CITY COUNCIL AGENDA ITEM

Subject: PUBLIC HEARING (AUGUST 11, 2025) – CONDITIONAL REZONING – (JPCR2025-002) – Proposed Northland Enclave, West side of Corporate, North of Long Lake (5455 Corporate, PIN 88-20-08-451-004), Section 8, From O (Office) Zoning District to CB (Community Business) and MF (Multifamily) Zoning Districts

Conditional Rezoning and Preliminary Site Plan Approval Review
For
City of Troy, Michigan

Action Requested: Conditional Rezoning and Preliminary Site Plan Recommendation

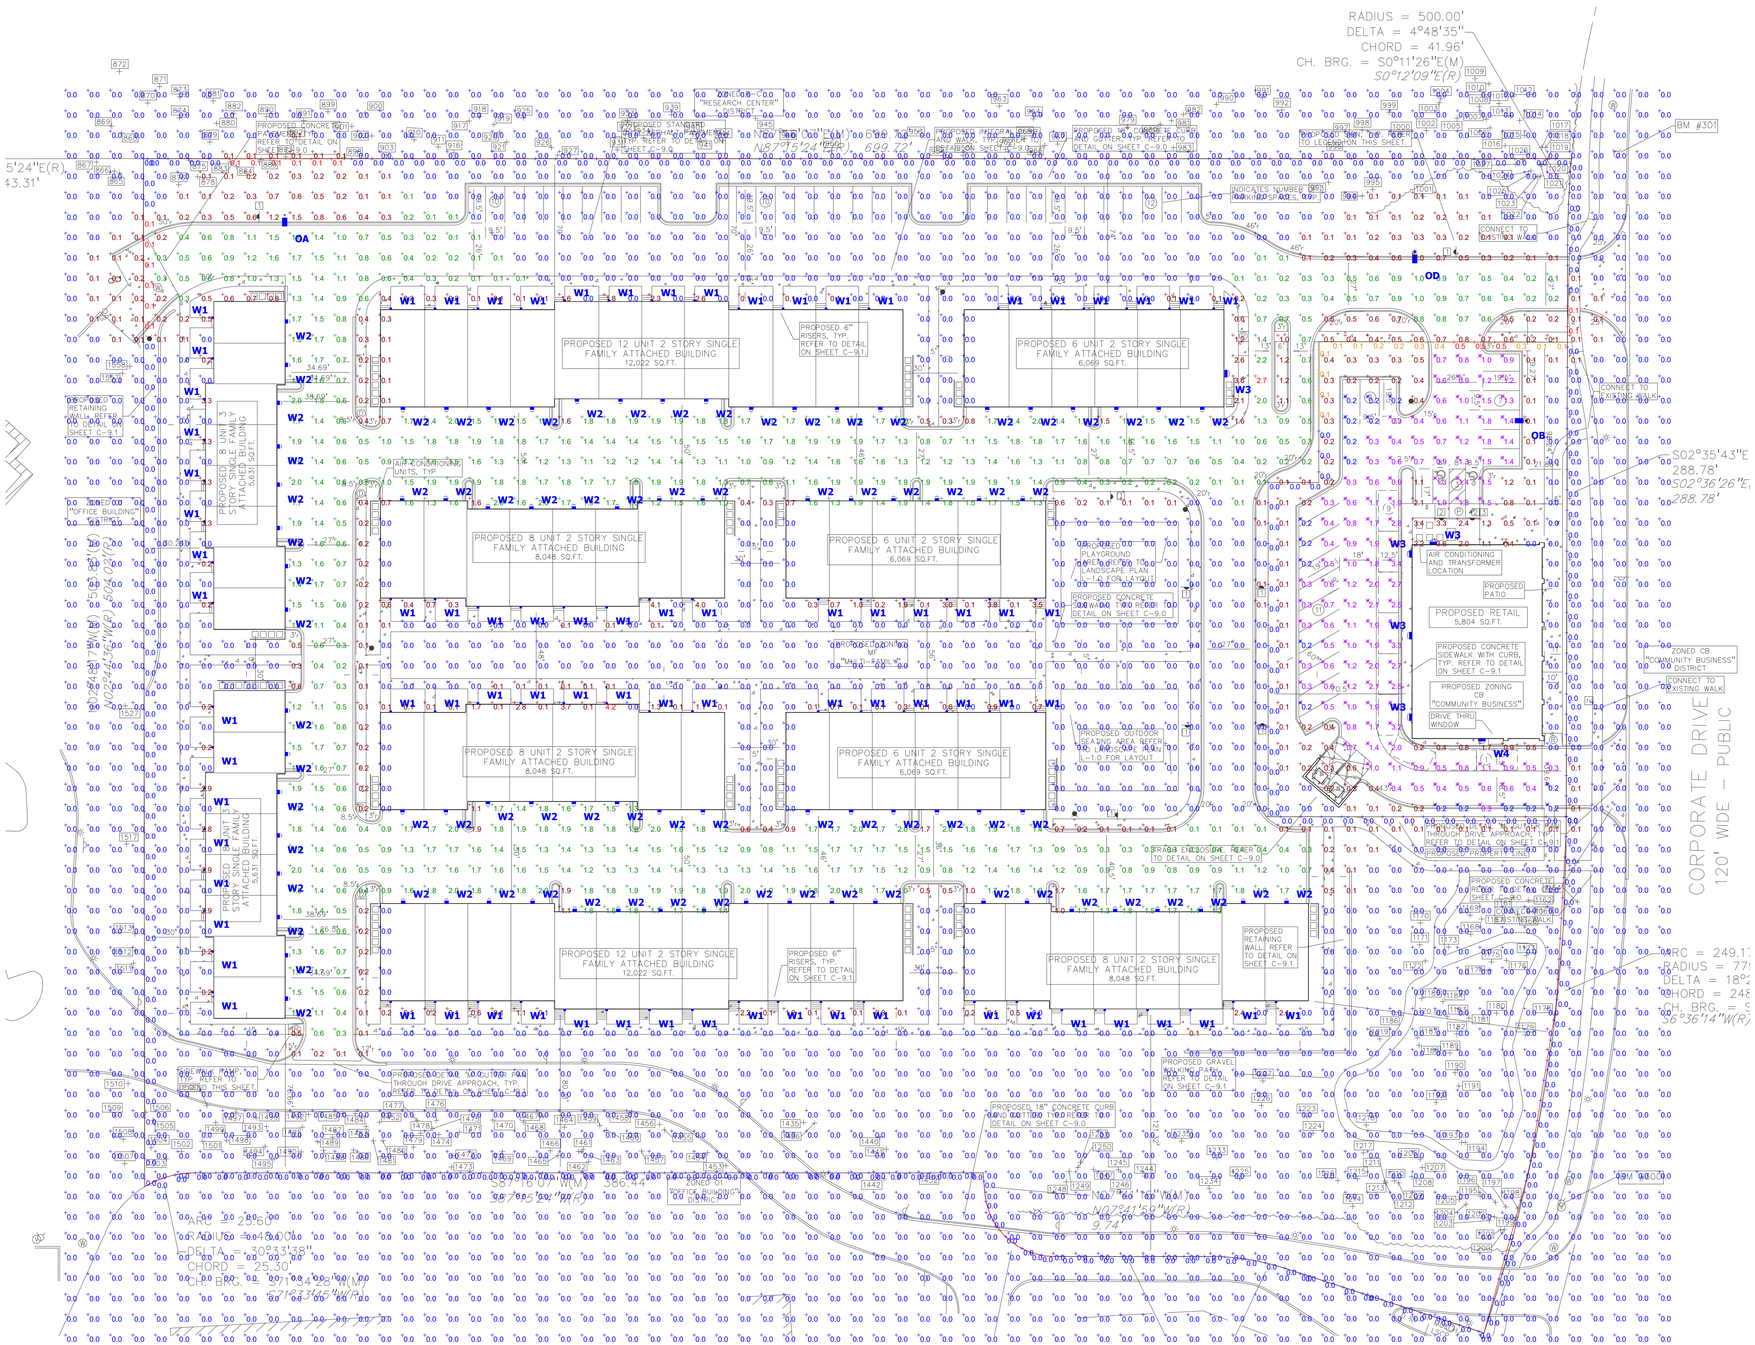
revise the photometric plan to bring lighting levels into compliance with Section 13.05.2.b. In a response letter dated April 22, 2025, the applicant states that this issue has been corrected; however, we find that revised site plans still show that lighting levels around the retail site are too high.

1. *Increase stacking by one (1) space*
2. *Provide screening around exterior air conditioning units.*
3. *Reduce lighting levels to 0.1 footcandles along retail boundaries adjacent to residential.*
4. *Provide color rendering of side and rear (garage) elevations*

Retail Building

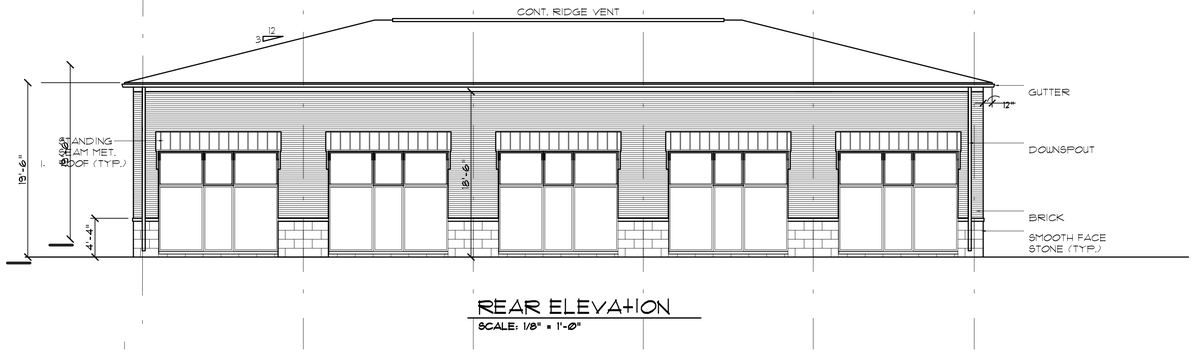
- Gravel walking path; approximately one acre.
- Placement/location of mechanical equipment.
- Design of entrance to the project.
- Front doors of residential units limit outdoor seating, engagement with neighbors.
- Consideration by applicant to create front porches.
- Consideration by applicant to add seating (benches) in center courtyard.
- Consideration to mirror commercial front and rear elevations.

7 Redesign the facade on the rear of the commercial building to mimic aspects from the front of the commercial building.
8. Include the Site Plan as a voluntary condition of the Conditional Rezoning application to the satisfaction of the City Attorney.

- Provided 7' wide entry porches (see Sheet C – 3.0)
- Provided seating benches throughout courtyard (see Sheet L -1.0)
- Provided retail building rear elevations like front elevations (see Sheet A 1.1)
- Provided 10 car stacking spaces (see Sheet C – 3.0)
- Provided screening around exterior air conditioning units (see Sheet L – 1.0)
- Reduced lighting levels to 0.1 footcandles along retail boundaries adjacent to residential (see Photometric Site Plan 1 of 2)
- Provided color rendering of side and rear (garage) elevations (see Sheets A.3 and A11)

Mr. Nikolla confirmed the voluntary conditions offered are:
- 7 foot wide by 7 foot deep front walkways.
- Additional benches.
- Facades of the retail building mimic each other.
- Approval of the Site Plan application.
